United Nuclear - Mallinckrodt

Feb. 27, 1962

70-36
S-8

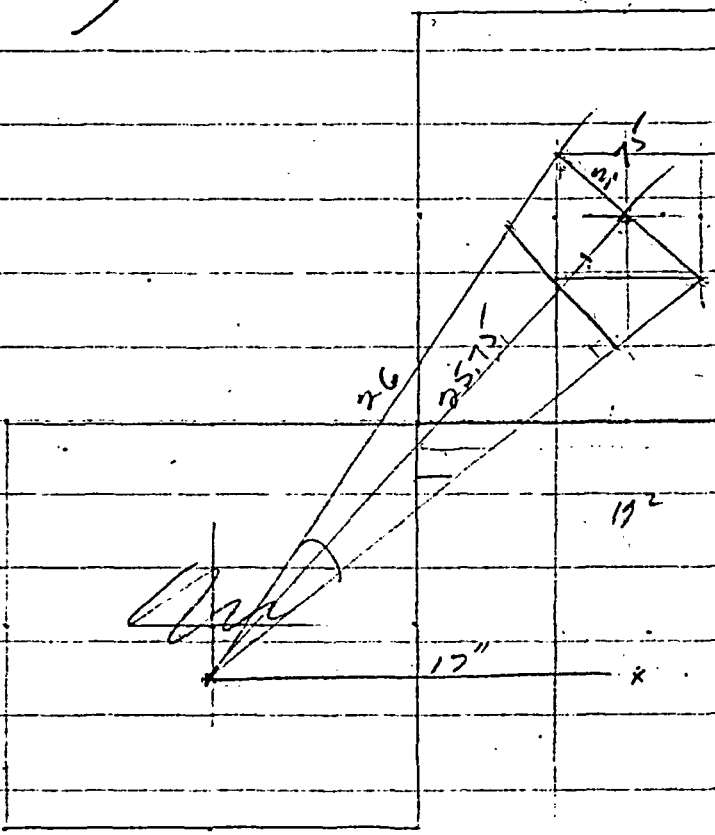
Value somewhat high
because upper container
initially

drum in 12
direction
upward and below

VS Un. Nuc. .7+
Value results too low
because they assumed
spheres.
